## Submit comment on September 27-28 Stakeholder Call Discussion

2021-2022 Transmission planning process

The Bay Area Municipal Transmission group (BAMx)<sup>1</sup> appreciates the opportunity to comment during the development of the 2021-22 Transmission Plan. The comments and questions below address the material presented at the CAISO Stakeholder meeting on September 27-28, 2021.

**Figure 2: A Comparison of the CAISO’s HV TAC (\$/MWh) and Assumed Capital Expenditures (M\$)**

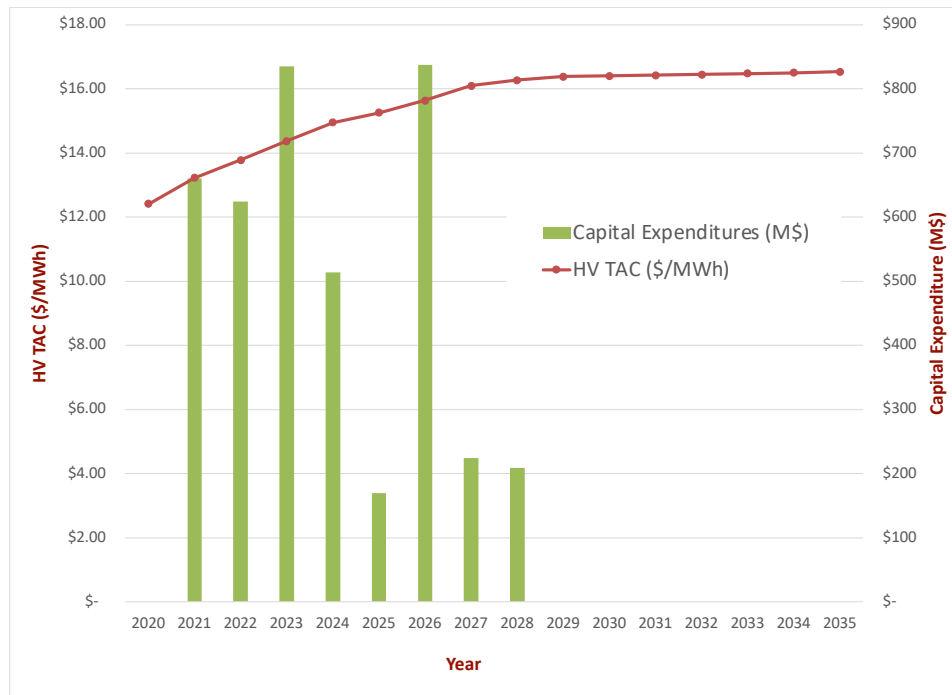
BAMx notes that the tapering of the CAISO’s HV TAC forecast in the outer years, that is, during 2027-2035, is primarily driven by the very low (or no) levels of transmission capital expenditures assumed in the HV TAC forecasting model. As shown in Figure 2, the HV TAC forecasting model assumes that the HV capital expenditures<sup>14</sup> will occur during the years 2023-2028, which is primarily driven by the CAISO-approved reliability-driven transmission projects.

Clearly, one of the major reasons for a lower level of capital expenditures assumed in the outer years (2028-2035) in the TAC Forecasting Model is that they do not include the capital expenditures in the CAISO’s upcoming TPP cycles. In other words, the HV TAC rates, especially for years 2028-2035, are likely going to be higher than those depicted in the current version of the HV TAC Forecasting Model. Furthermore, there needs to be a recognition that the HV TAC rates would be significantly greater upon the incorporation of the direct costs
